DEPARTMENT OF HIGHWAYS, ONTARIO  
TORONTO ONTARIO  
PROPOSED SPANISH RIVER BRIDGE  
WASSEY ONTARIO  
BEDROCK DETERMINATION BY RESISTIVITY

Re: M.P. 25-57 - District 18,  
North Approach Embankment,  
Proposed Spanish River  
Crossing, Massey, Ontario.

Re: W.P. 25-57 - District 18,  
Stability Analyses,  
North Approach Embankment,  
Proposed Spanish River Crossing,  
Massey, Ontario.

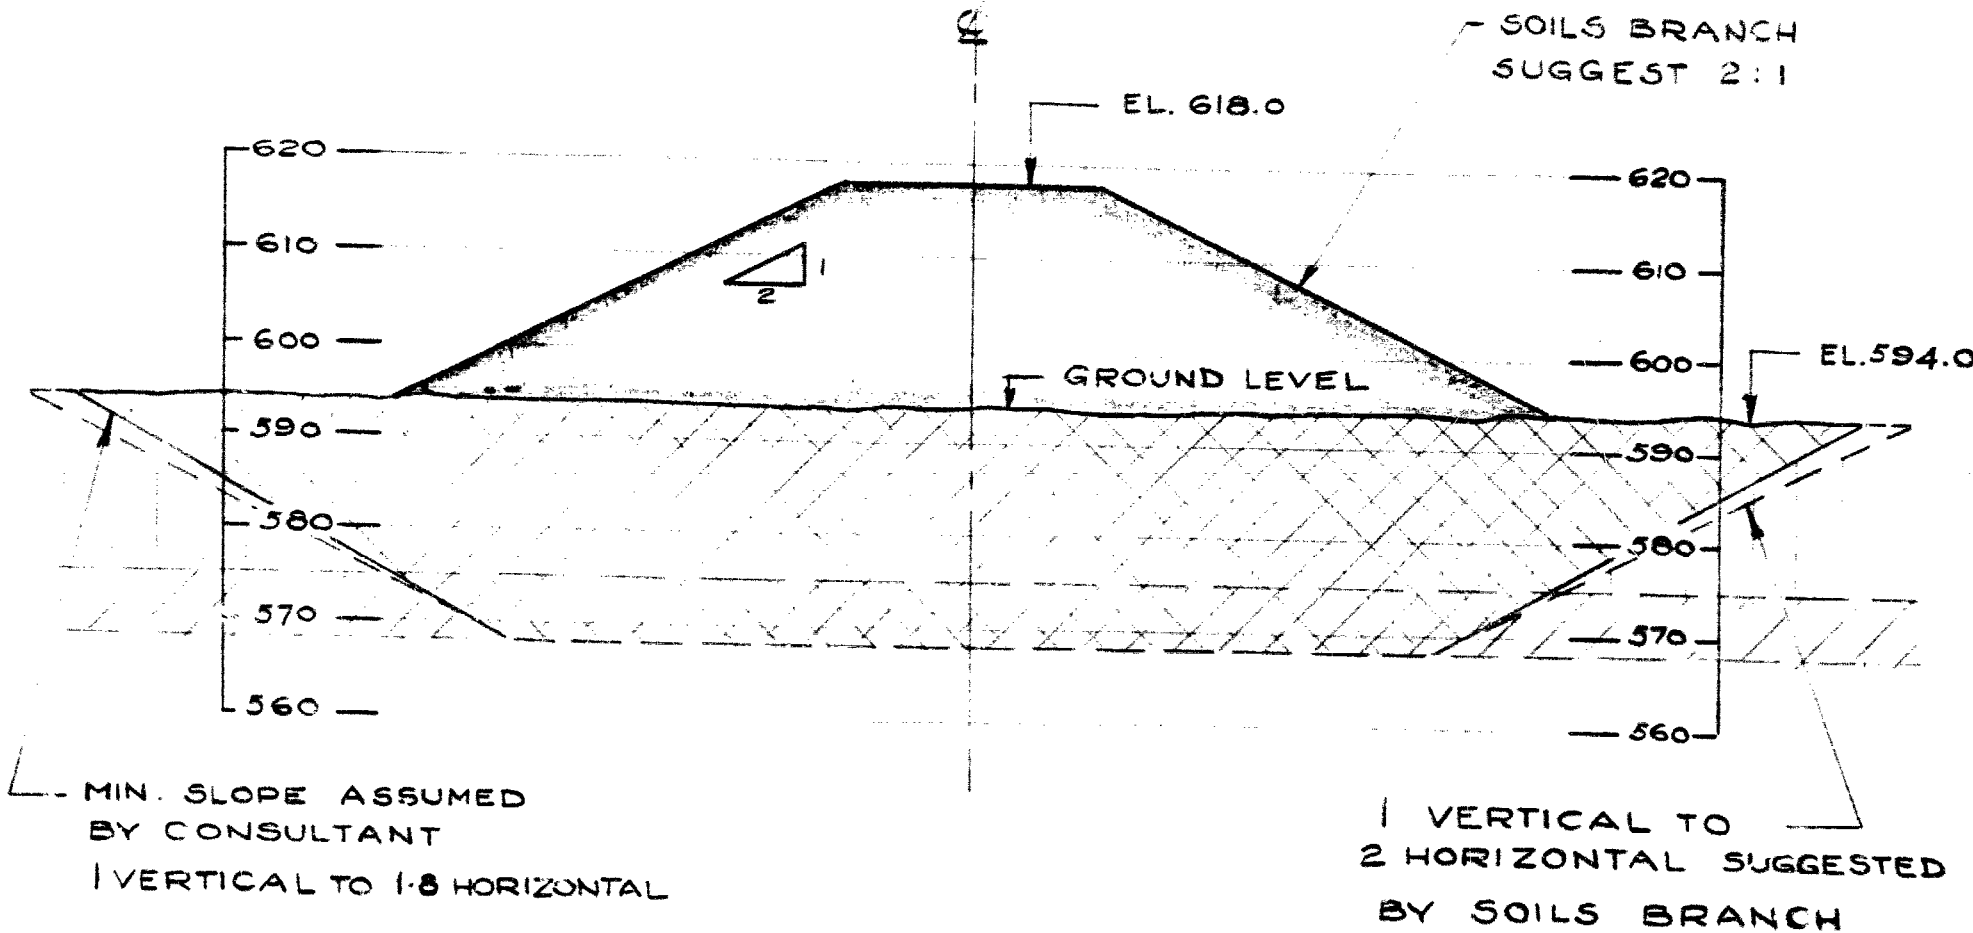
The finished grade line has been  
reduced to Elev. 611 at this structure  
location. The original proposed grade line  
was at Elev. 618'. Because of this reduction  
in grade, the original proposal of Subexcavation  
was not considered necessary. Additional  
stability analyses were carried out by Geoscon  
LTD. indicate that the approach abutment  
at the north abutment can be built to  
the elevation (611) with minor beam requirements.  
The recommended beam section to be constructed  
is shown in Drawing No. S7053-1 of Geoscon's  
Report dated the 11th of April, 1960. A  
memo by L. G. Soderman on the 19th of  
April, 1960 was sent out to all the  
parties concerned together with this report  
of Geoscon's. In view of the fact that  
Geoscon's analyses had not been taken into  
consideration, the height of the backfill  
between the abutment and ~~the~~ above the 2  
horizontal to 1 vertical slope shown on

this drawing, further additional analyses

was made by Crocon, taking this mass of  
rock into account. Crocon submitted their  
additional analyses on the 16th of May, 1960.  
This brief letter was sent out together  
with a memo by L. G. Sodeman on the  
18th of May to all the parties concerned.  
Results of the analyses have shown that  
the recommended berm section to be constructed  
contained in Crocon's Drawing No. 57053-1  
would be satisfactory. Due to the proximity  
of the toe of the berm to the river  
channel, in order to maintain a minimum factor  
of safety of 1.2 for stability, the size of  
the berm should be carefully controlled  
during construction.

SECTION B-B

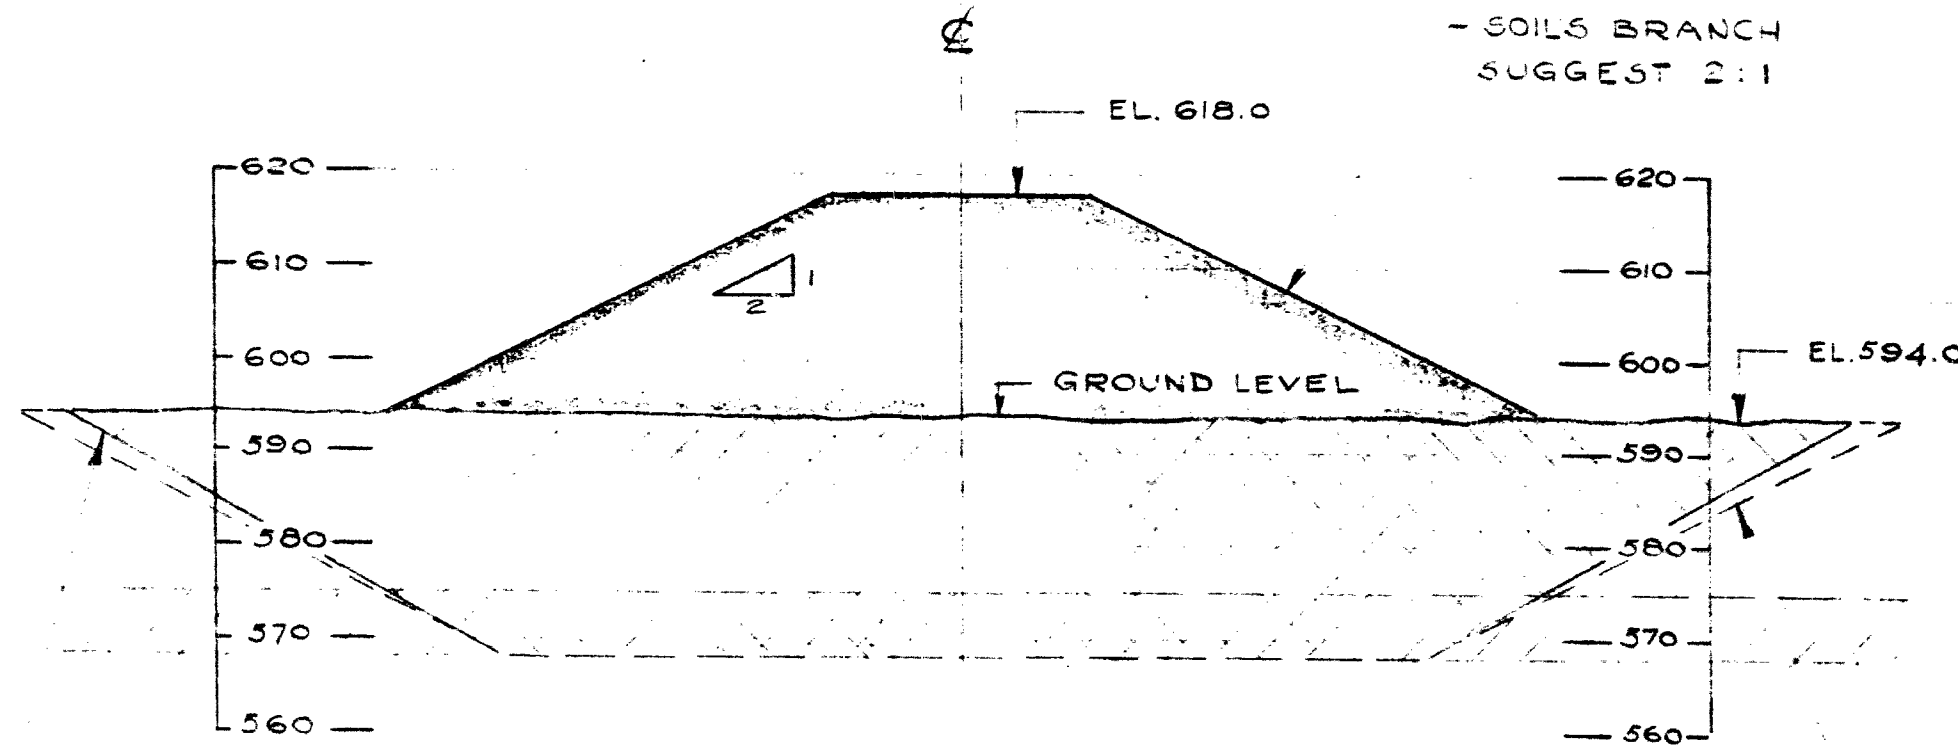
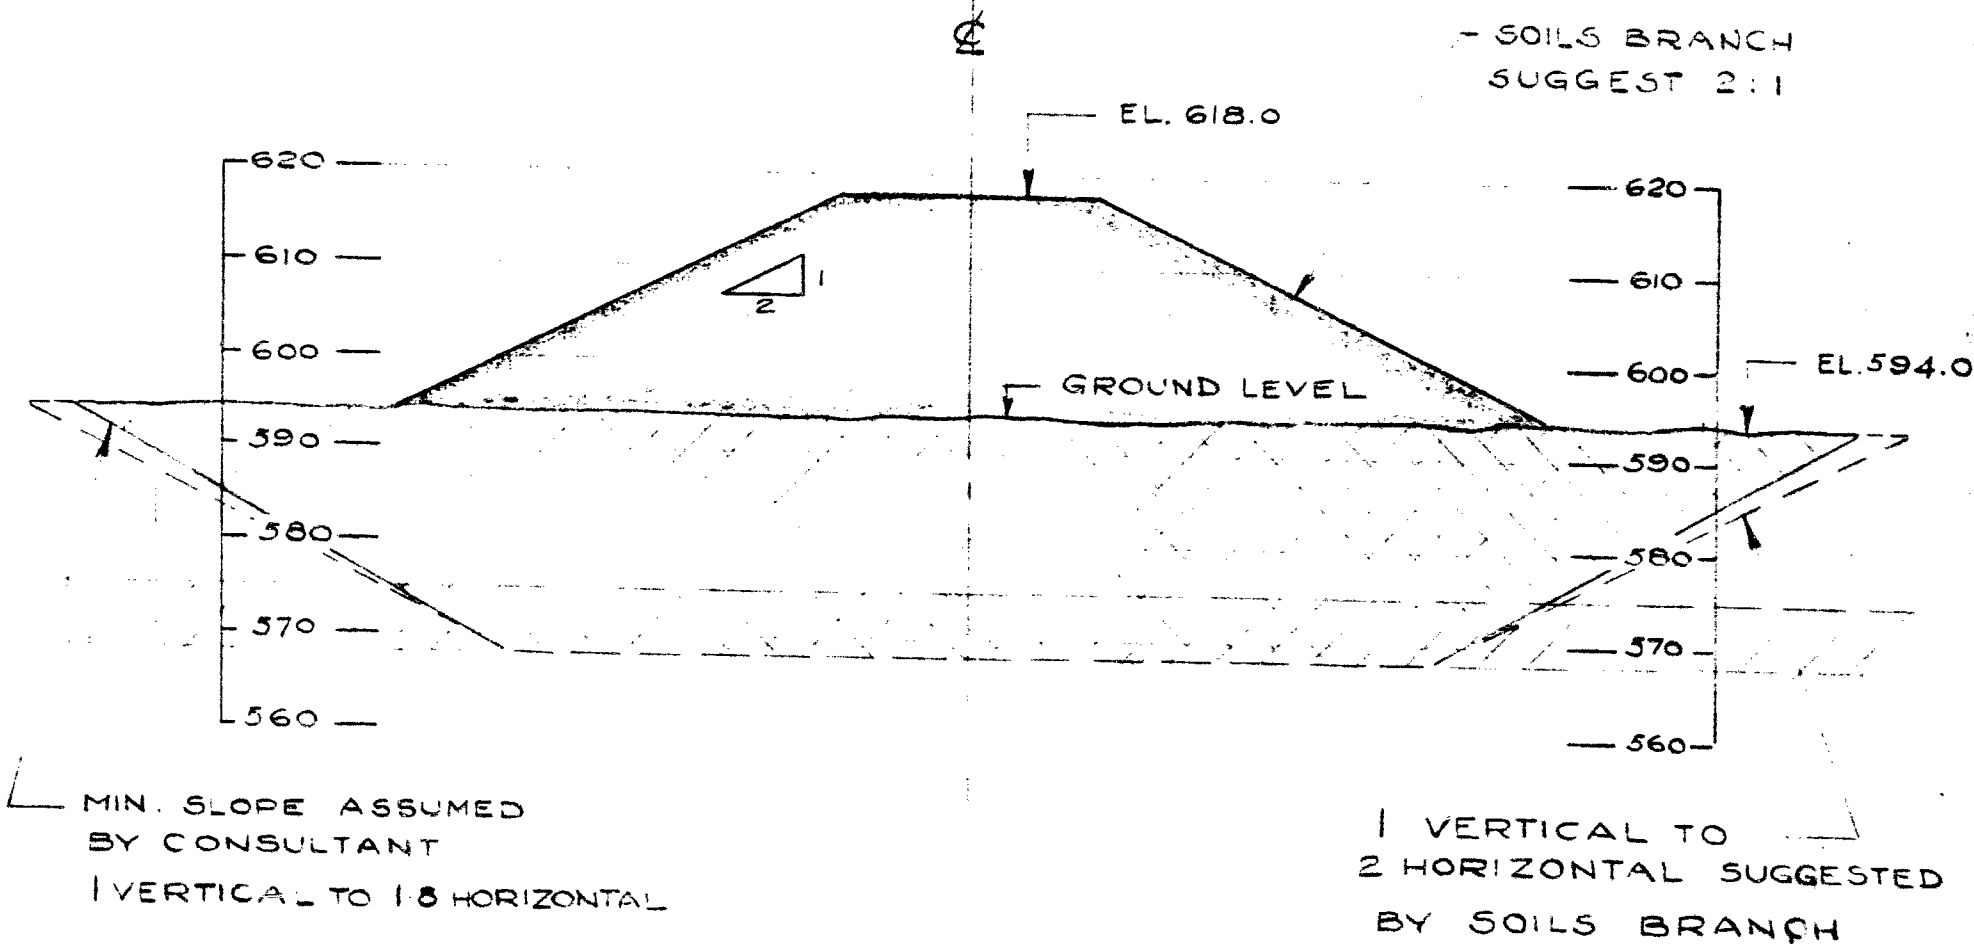
- SOILS BRANCH  
SUGGEST 2:1

1 VERTICAL TO  
2 HORIZONTAL SUGGESTED  
BY SOILS BRANCH
